SYNOPSIS OF PROFESSIONAL STAFF COMMENTS FOR PLANNING COMMISSION & CITY COUNCIL

Lots 1-94 and Outlots A-G, Spring View

**MDC PMG LLC (Owner)/McCune Development (Subdivider)/Lamp Rynearson (Agent)
Final Plat Application**

SPRINGVIEW

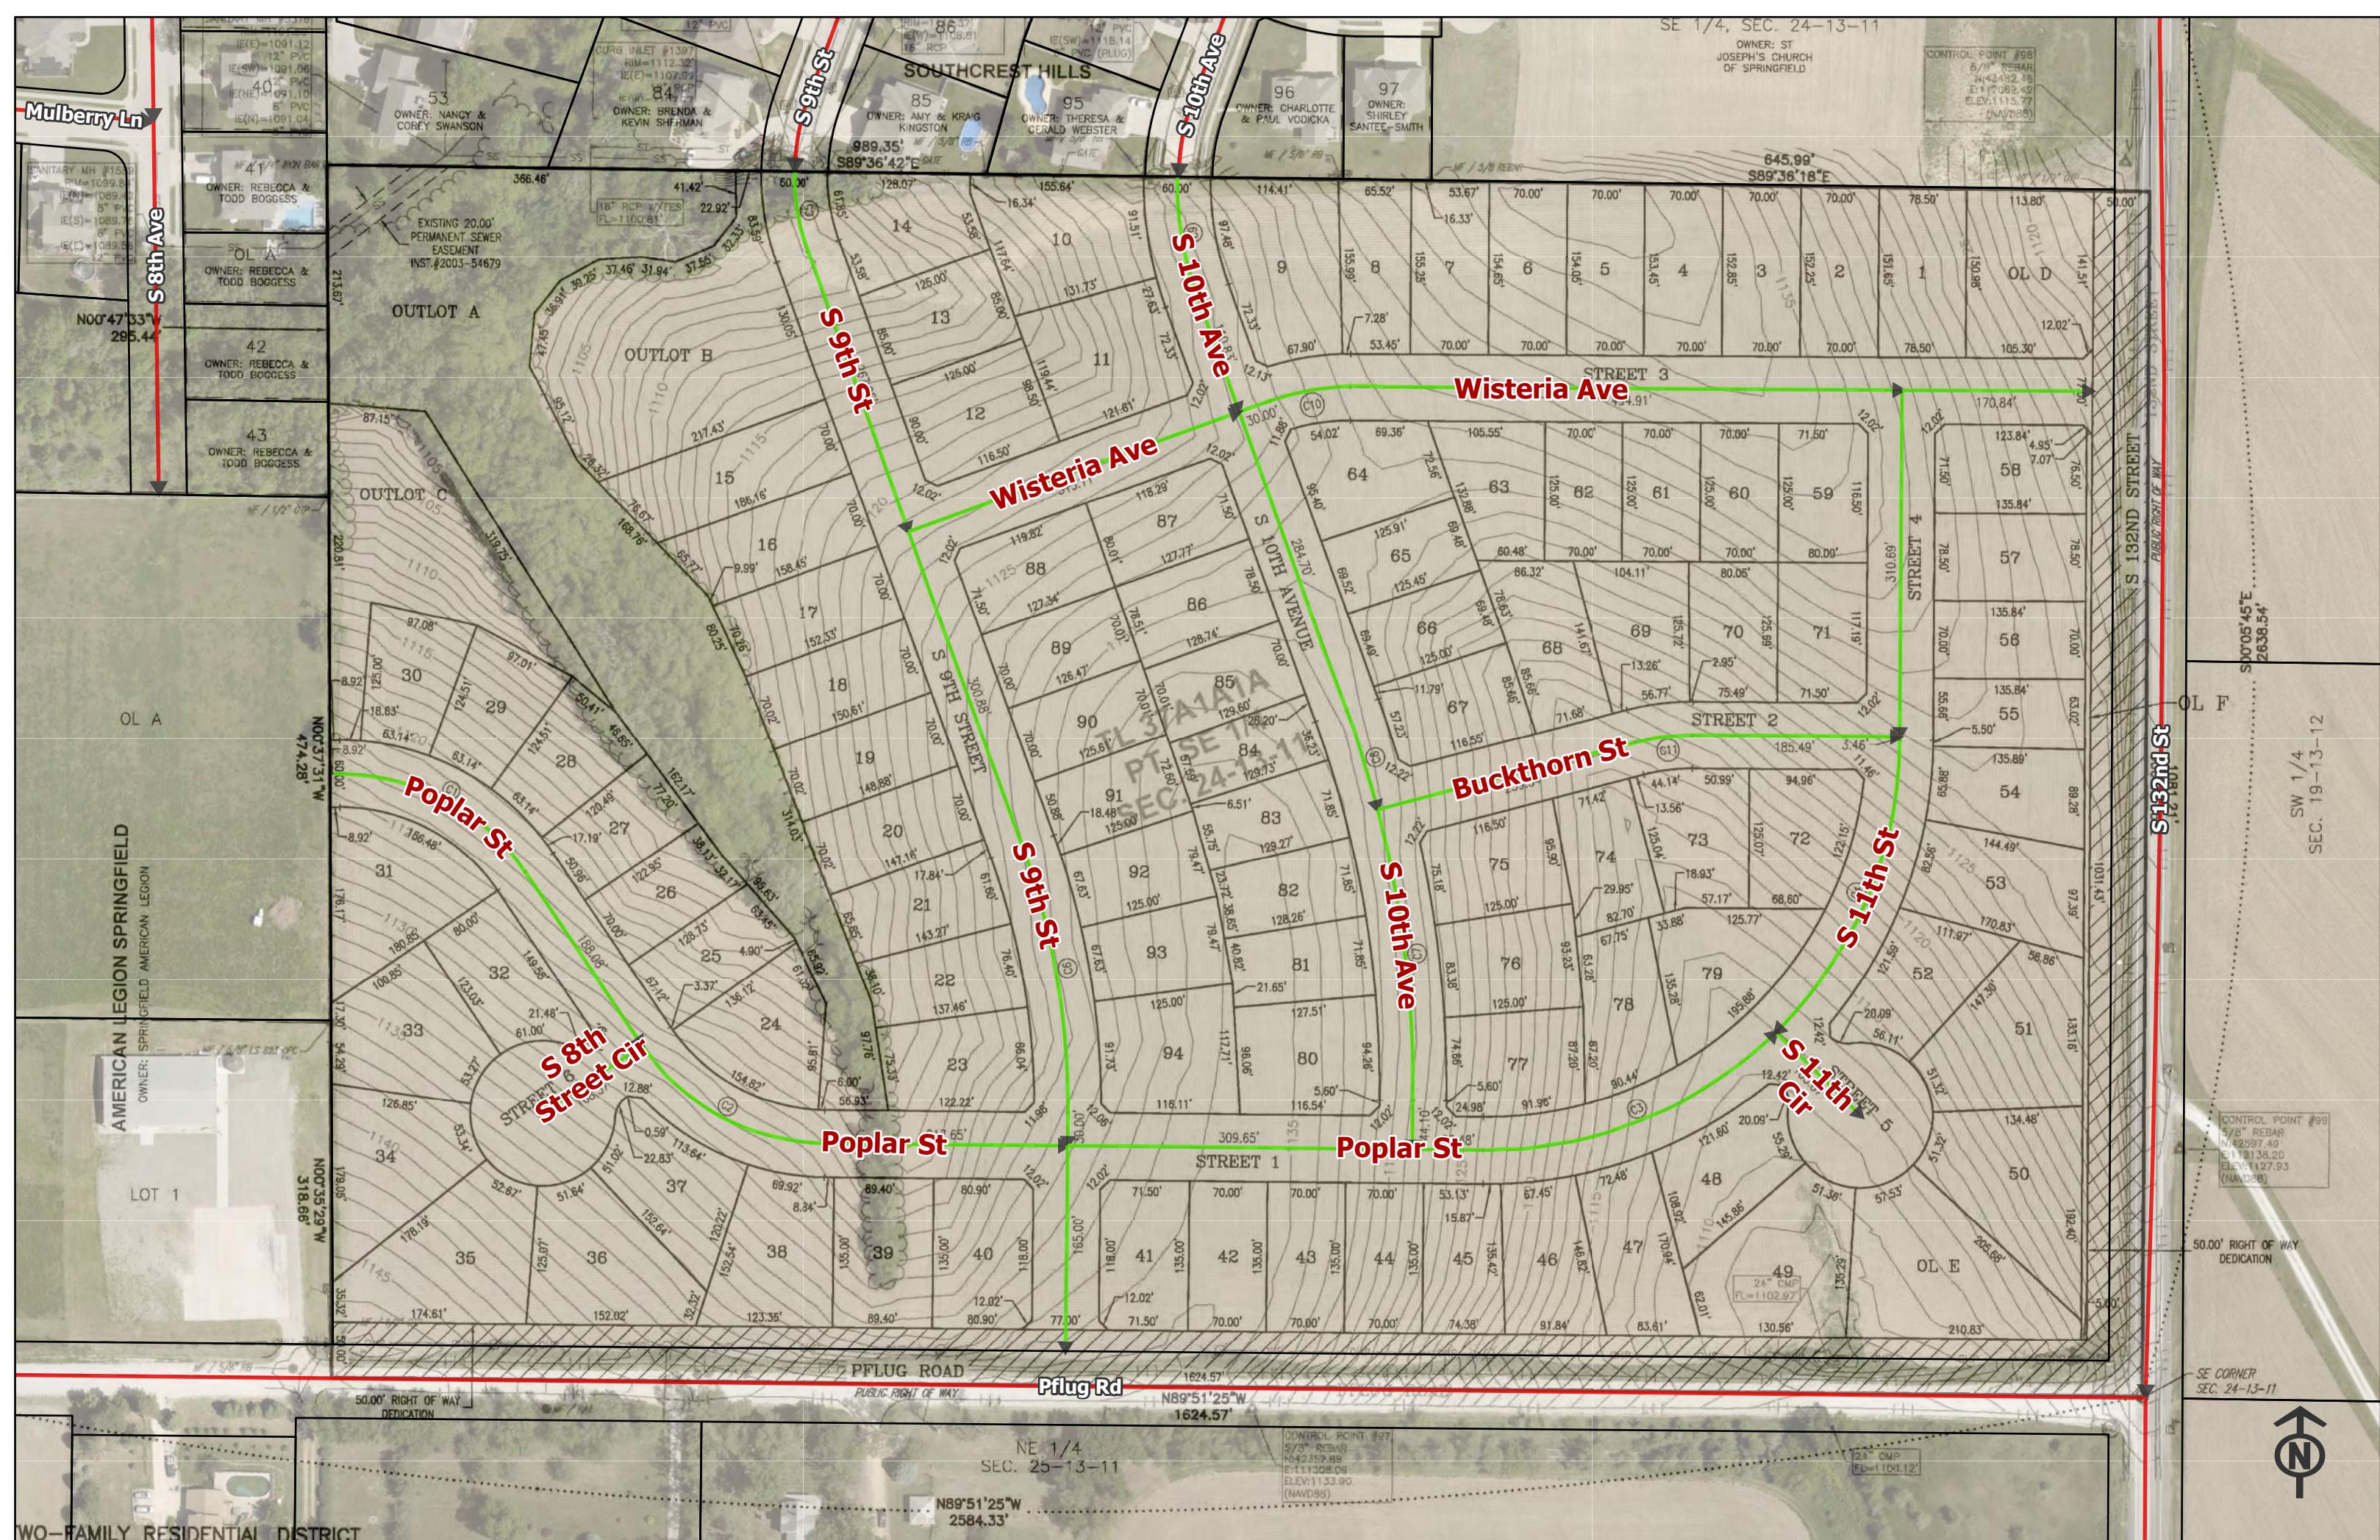
how is this found when there is no survey of record.
file a copy of the survey that shows you set this or
show this as being set and not found

why was this line broken into
segments when the previous
planting to the north, Southcrest
Hills, and survey by PLS 507 of
TL37A1A1B shows a singular
bearing and distance?
